Being a By-law to Amend Zoning By-law 2010-0050, as amended, of the Town of Halton Hills, Part of Lot 21, Concession 9, Town of Halton Hills, Regional Municipality of Halton (File Nos. D12SUB09.001 & D14ZBA09.006)

To: John McMulkin –Planner, Development Review
From: Steve Burt – Development Engineering Coordinator
Date: April 8, 2020
Regarding: **Zoning Amendment and Subdivision Application
McMaster Street and Megan Drive (Glen Williams)
Town of Halton Hills
Eden Oak (2147925 Ontario Ltd.)
File: D14ZBA09.006 and D12SUB09.001**

**Re: Deficiencies in Draft Plan of Subdivision & Zoning By-law Amendment
Applications – 1st Submission (Post OMB Appeal)
File Nos.: D12SUB09.001 & D14ZBA09.006
Project: Eden Oak – McMaster Street & Meagan Drive – 24T-09001/H**

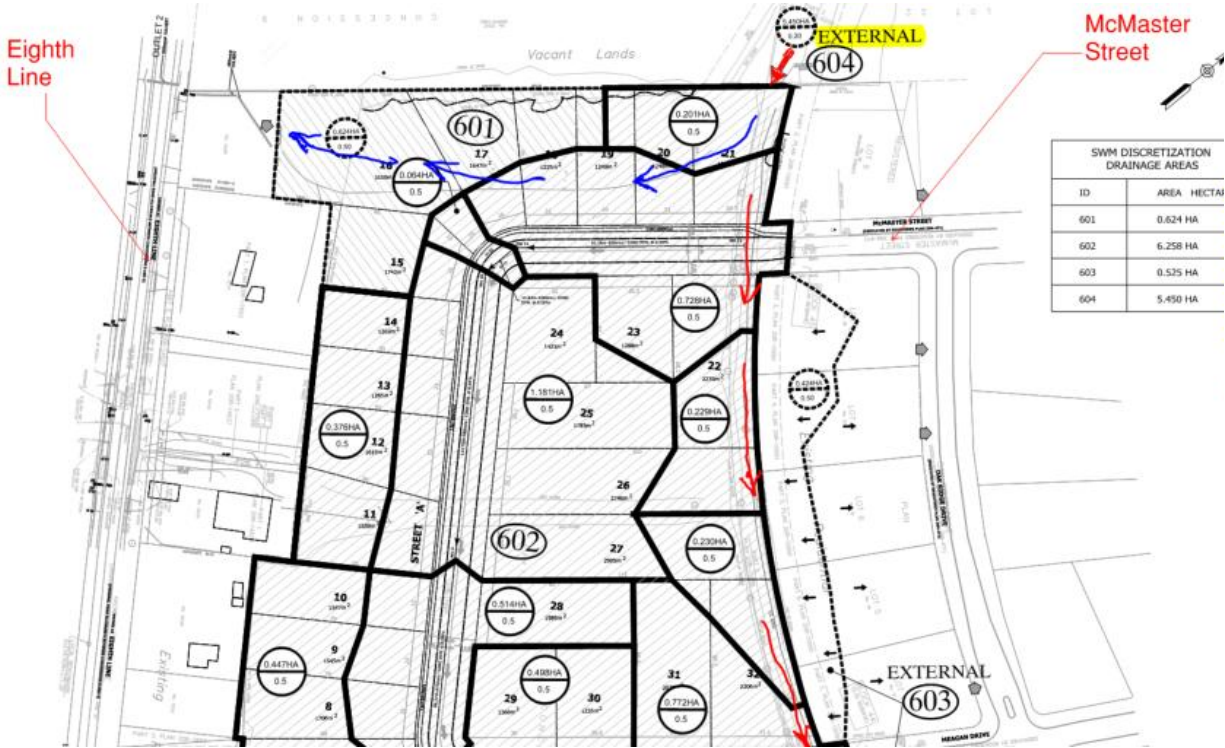
A fundamental issue has emerged that was discovered independently by Town staff and Burnside. It has the potential to change the engineering designs and we have decided to highlight this issue rather than continuing to produce a letter of detailed comments on the current application. The issue has to do with external drainage water that enters the northeast corner of the site from adjacent farmland. In general, the design engineer has considered this water to bypass the subdivision along its eastern boundary in both the pre-development and post development conditions. Town staff and Burnside believe that in the pre-development condition this water in fact turns west after entering the subdivision lands and flows toward the Eighth line. A more detailed explanation follows.

The following excerpt from the Function Servicing Report (November 2019) describes this offsite water as area 604:

303. As depicted on Figure 8; two other catchment areas are identified; 603 and 604 which are external to the plan and drain to an existing ditch that runs along the north-eastern limit of the Site. These external drainage areas were also modelled using SWHYMO however they are NOT tributary to the proposed stormwater management pond and diversion / conveyance of flows will be discussed in greater detail in Section F.3.0 of this report.

Mapping is provided as Figure 8. I have marked up that plan to label Eighth Line and McMaster Street for orientation purposes. I have highlighted the word "External", showing where the water enters the property. This drainage area is 5.45 hectares. My red arrows show where the water
